Access Compliance Report Public Rights-of-Way (Curb Ramps)

Main Street: PROSPECT AVE **Cross Street: 17TH ST** SW Location:

ADA ID: RPRK220124102942 Ramp Type: Type 1 - Perpendicular Diagonal Initial Pass/Fail: Pass **Overall Compliance: No Severity Score:**

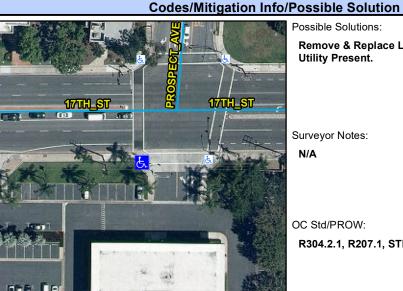
Remove & Replace Landing. Restripe Crosswalk. **Utility Present.**

R304.2.1, R207.1, STD 1115
